**1601 E AMERICAN BLVD  
HILTON GARDEN INN - CORRIDORS & GUEST RO**

# REQUEST FOR COUNCIL ACTION

Originating Department <b>Community Development</b>	By <b>GPD</b>	Approved for Agenda by:	Date:  Time:	Number:
Agenda Section <b>DEVELOPMENT BUSINESS</b>		Item <b>Rezoning, Preliminary and Final Development Plan</b>

Case 9294A-97

BUILDING ELEVATIONS		DATE: JUNE, 1997	
PLAN		SECTION	
DRAWN BY: JAD			
PROJECT: HERITAGE INN 200 UNIT MOTEL - X-1A BLOOMINGTON, MD.		PROJECT NO. 97-101

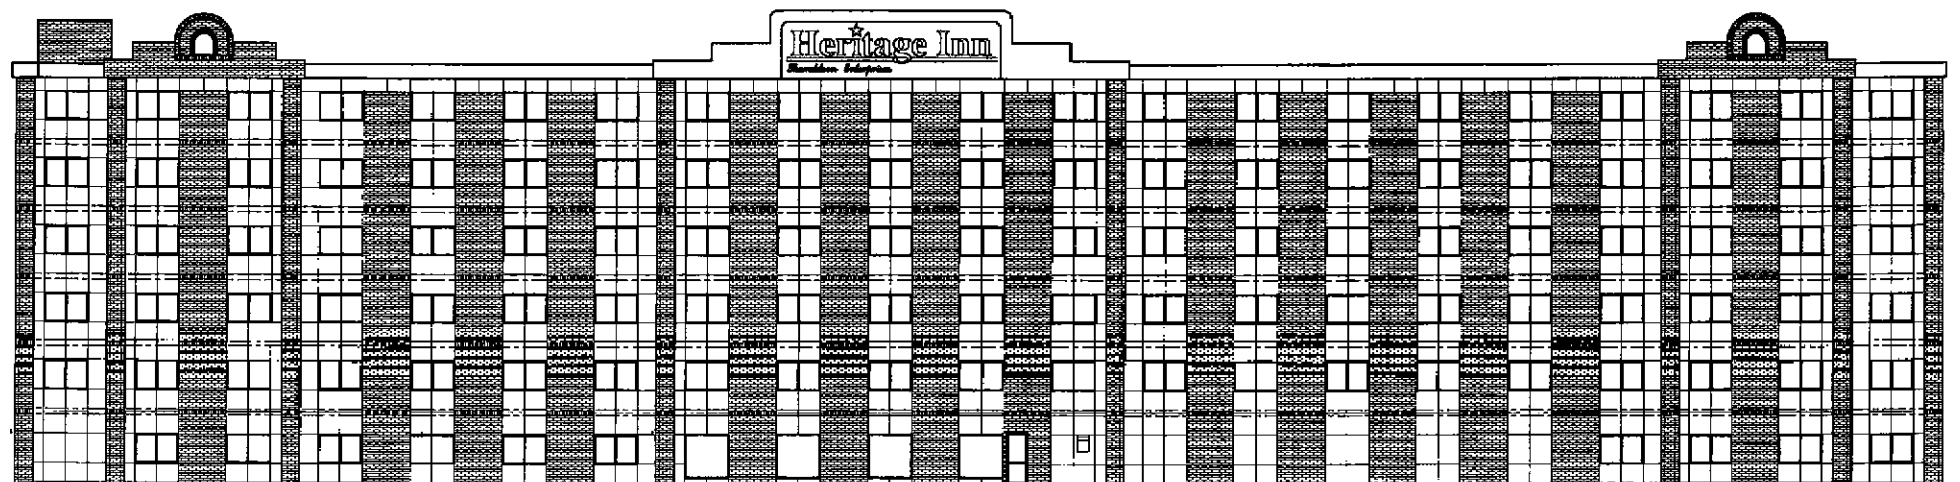
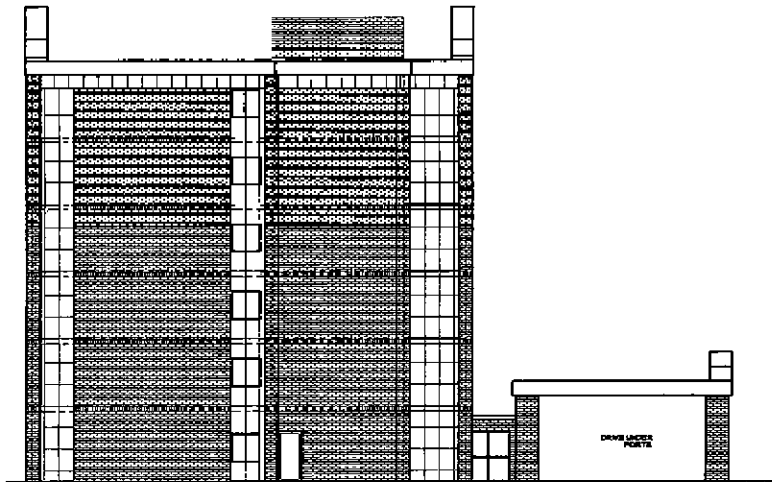
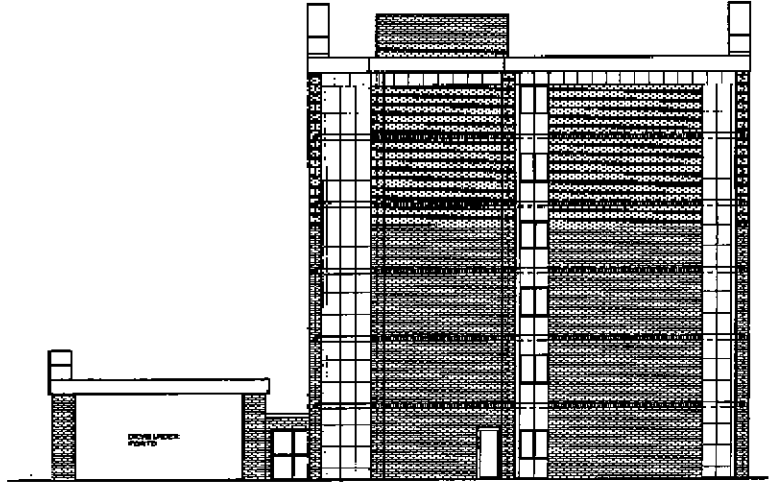
Revised hotel building elevations now show an exterior finish of three types of brick and have eliminated the use of any noncomplying materials. Staff does have some concern over the proposed elevations and will be discussing additional detailing with the developer to break up the long rectangular facades.

Designer  
Date  
October 11 2015  
Scale  
1"=20'-0"  
Drawing No.  
Summary  
1 of 1

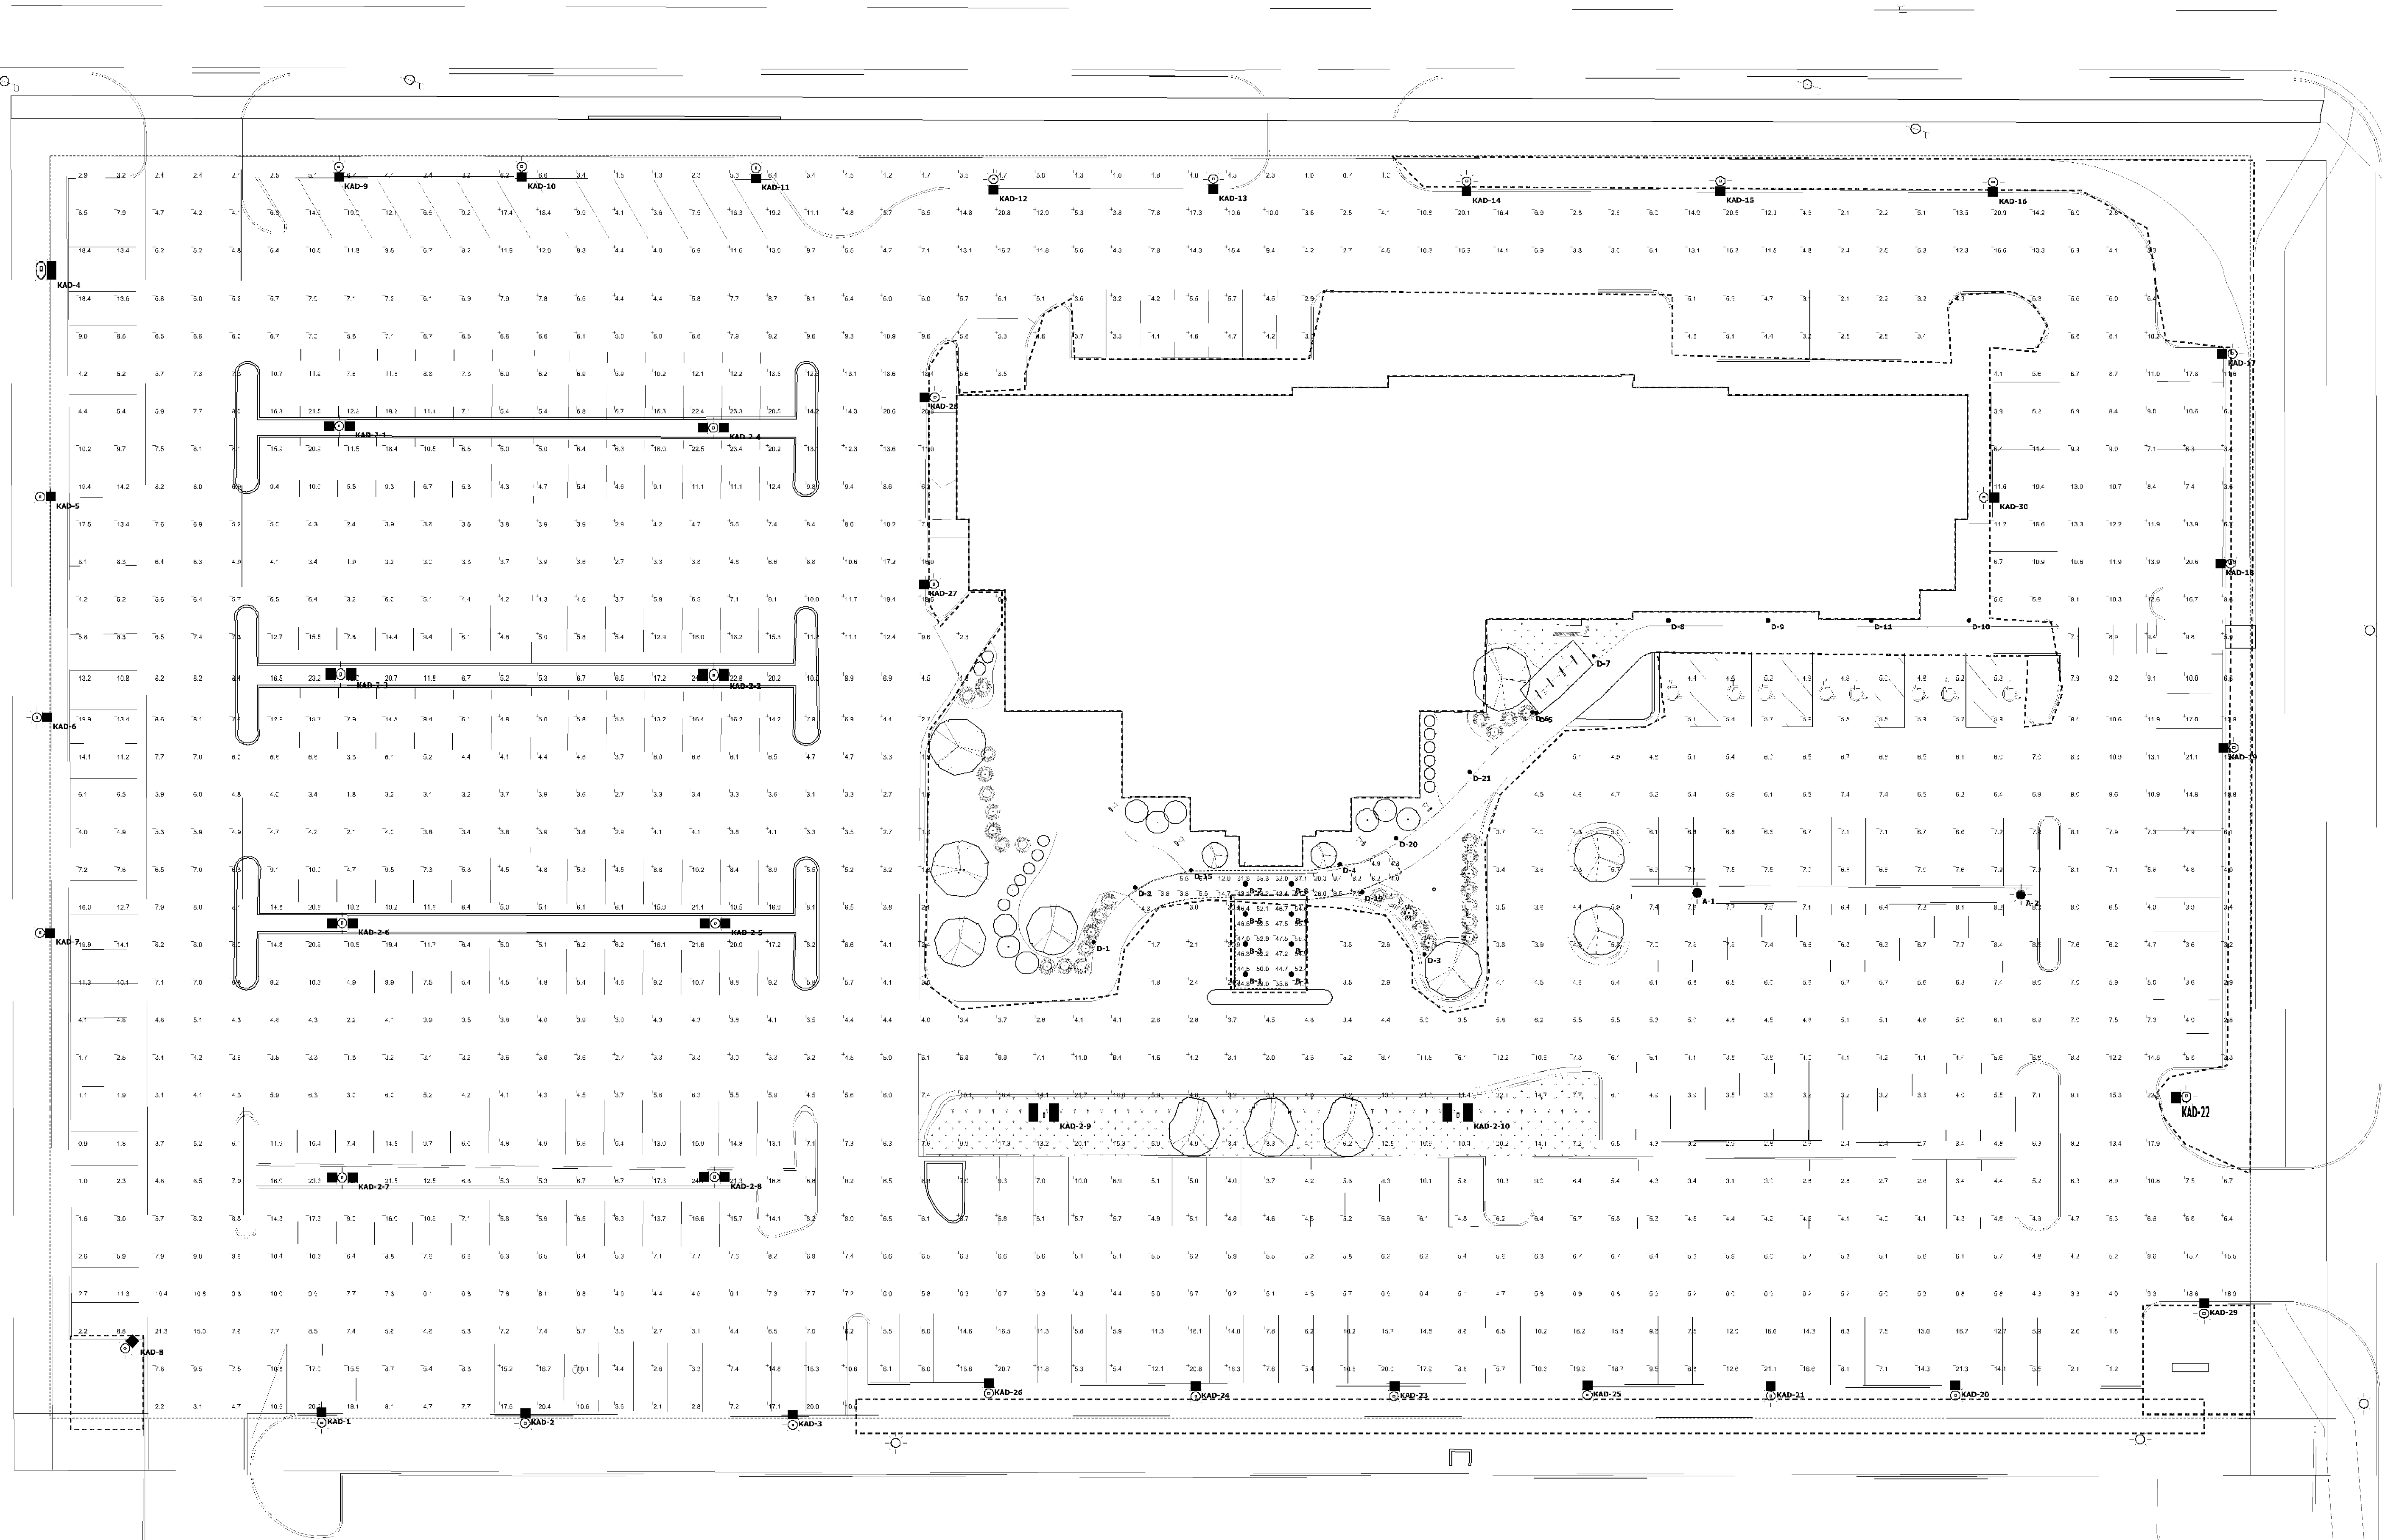
- 1) No Certificate of Occupancy without inspection. CODE REQUIRES compliance with the approved plan. Individual points may not vary more than 20 percent with the average of all points within 10 percent of the initial foot-candle level on the approved initial plans.
- 2) No change in fixture by manufacturer, type or order number without review and approval shall be permitted.

# Landscape Plan Approved

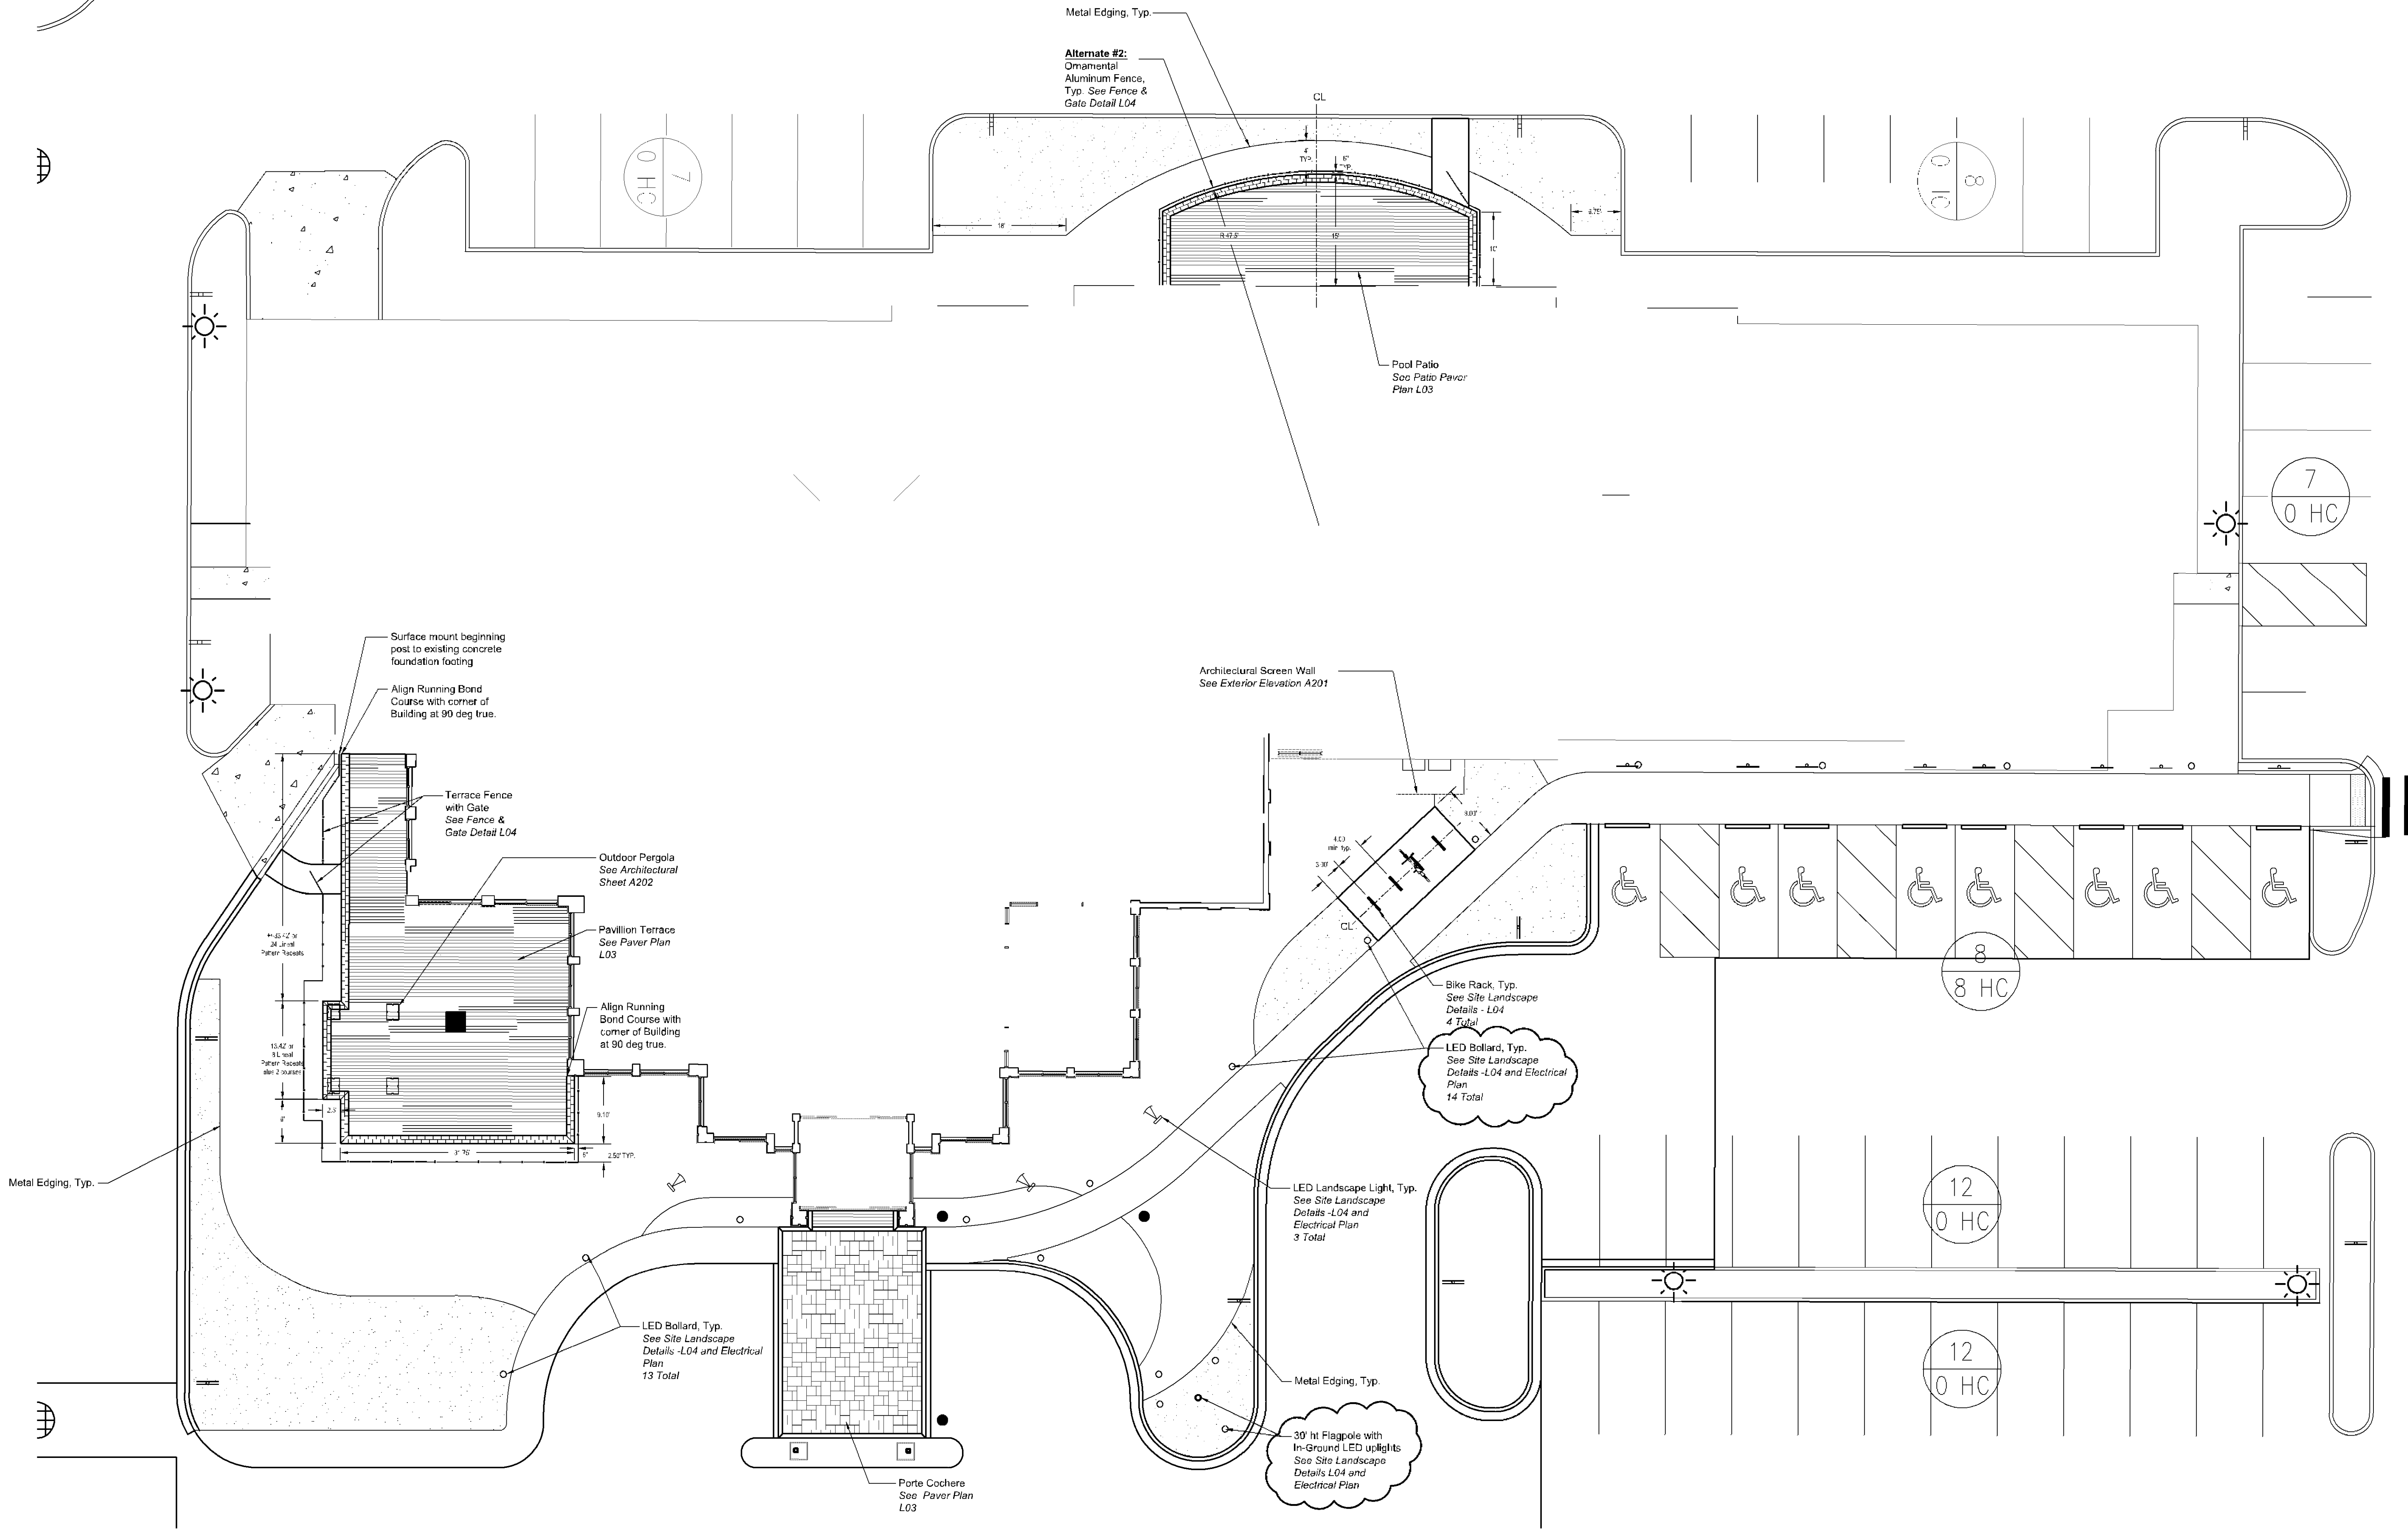
Installation must be fully installed and inspected prior to the Certificate of Occupancy. The surety will be held until all materials have survived one growing season.
